Product Change Notice (PCN)

PCN Number: PCN-0450358R-01

Product(s) Affected: SDF-40J, SDF-50J, SDF-60J, SDF-80J, SDF-130J

Reason(s) for Change: Manufacturing build location change.

New Design SDF-40J

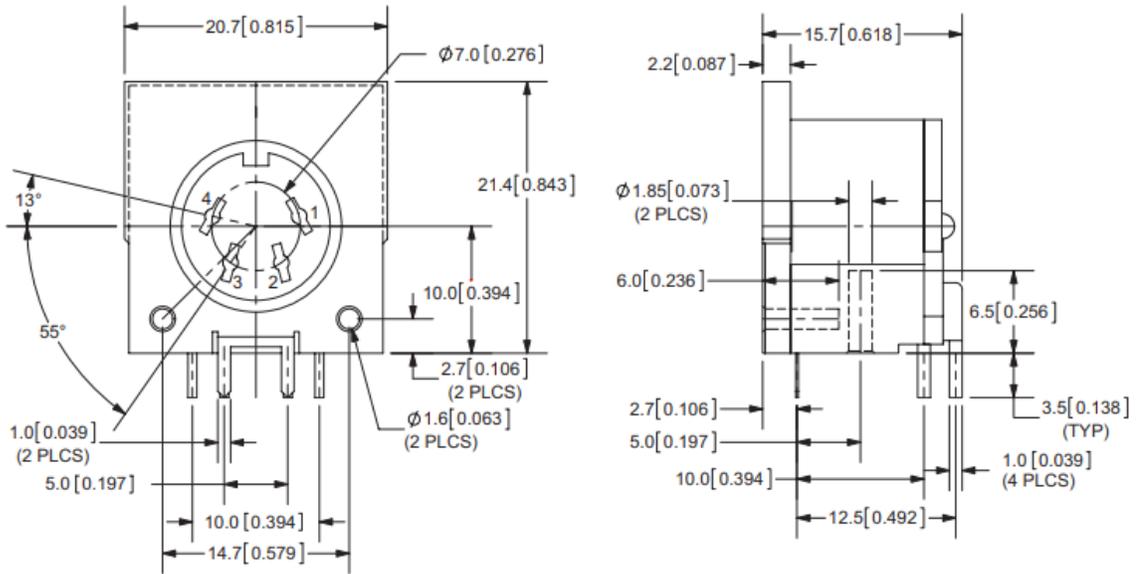
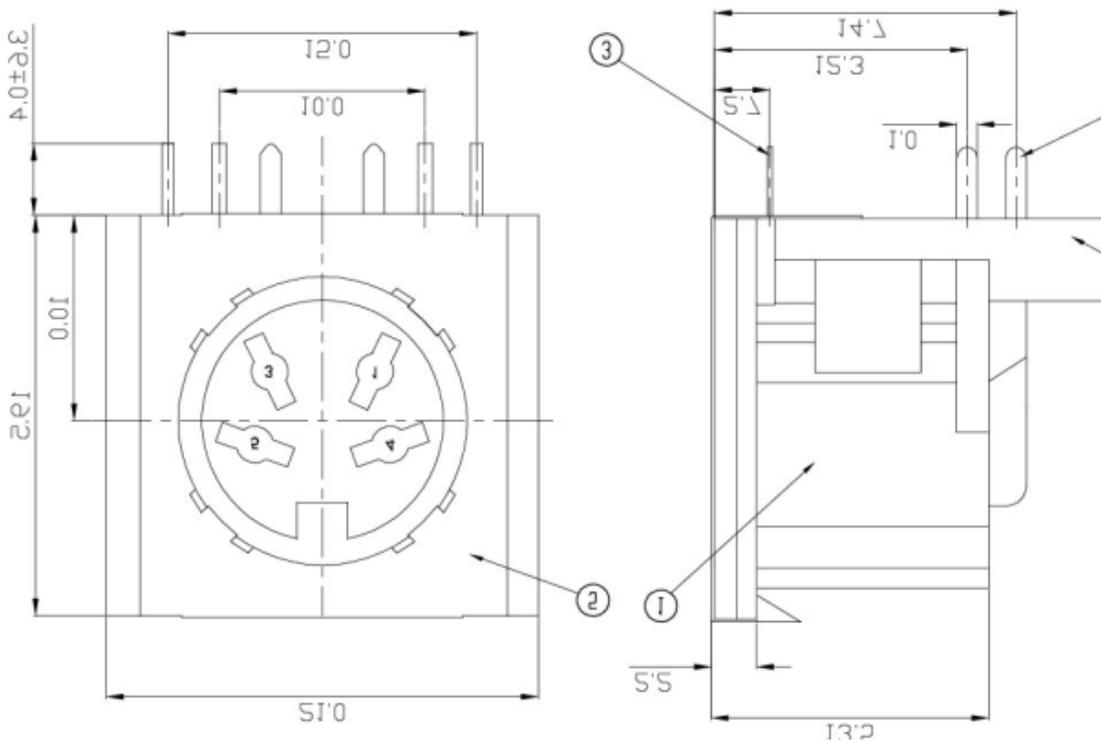
Description of Change: Dimensional and mechanical changes as shown below.
Note that PCB layouts have been adjusted to match the new mechanical changes.
